NZ 55/06 JAPAN – Nansei Syoto – Amami-Ō-Shima - Westwards – Depth.

Chart NZ 14052 (INT 52) [ 35/06 ]

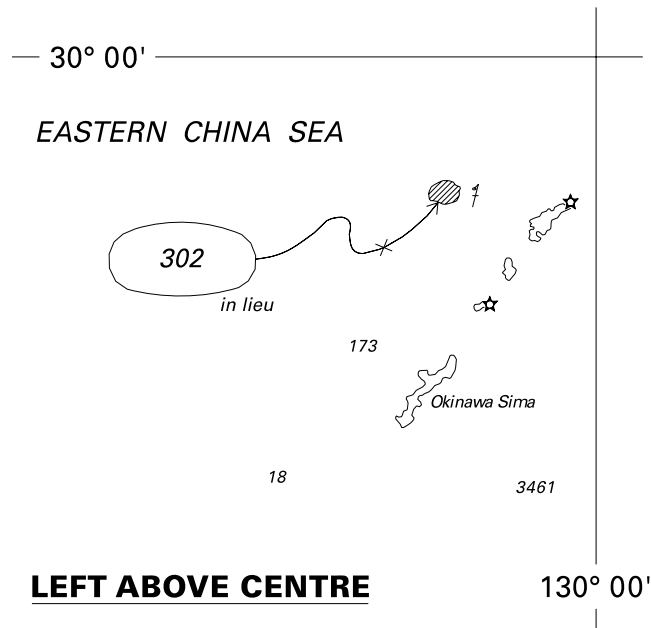
Substitute depth 302m for depth 365m and enclosing  28° 32'.0N., 128° 12'.0E.
